Access Compliance Report

Public Rights-of-Way

Intersection ID: 3850	Main Street: MOUNTAIN_COVE_DR	Cross Street: SHADOW_COVE_LN	Location: E
ADA ID: B56929674E7A	Ramp Type: Perp	Initial Pass/Fail: Fail	Overall Compliance: No
		Severity Score: 10

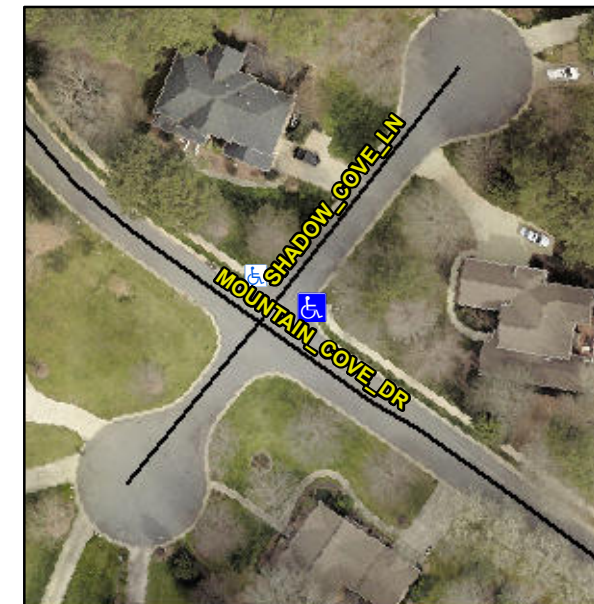
Not Found, R304.5.1, R304.5.3

Compliance	Description	Data	Compliance	Description	Data
N/A	Ramp Length (in)	46.0	Yes	Ramp Slope (%)	6.8
No	Ramp Width (in)	46.0	No	Ramp XSlope (%)	3.8
N/A	Flare Type LT	N/A	N/A	Flare Type RT	N/A
N/A	Flare Slope LT (%)	N/A	N/A	Flare Slope RT (%)	N/A
N/A	Flare Traversable LT?	N/A	N/A	Flare Traversable RT?	N/A
N/A	Landing Length (in)	N/A	N/A	DWS Provided?	N/A
N/A	Landing Width (in)	N/A	N/A	DWS Contrast?	N/A
N/A	Landing Slope (%)	N/A	N/A	DWS Length (in)	N/A
N/A	Landing X Slope (%)	N/A	N/A	DWS Full Width?	N/A
N/A	Landing Curb? (Y/N)	N/A	N/A	DWS Offset (in)	N/A
N/A	Shared Landing?	N/A			
N/A	Gutter Ponding?	N/A	N/A	Gutter Slope (%)	N/A
N/A	Gutter Lip Ht (in)	N/A	N/A	Gutter X Slope (%)	N/A
N/A	Painted X Walk1?	No	N/A	Painted X Walk2?	N/A
	X Walk 1 Direction	To NW		X Walk 2 Direction	N/A
N/A	X Walk 1 Width (in)	N/A	N/A	X Walk 2 Width (in)	N/A
	X Walk 1 Slope (%)	1.4		X Walk 2 Slope (%)	N/A
	X Walk 1 X Slope (%)	3.8		X Walk 2 X Slope (%)	N/A

Remove & Replace Entire Ramp.
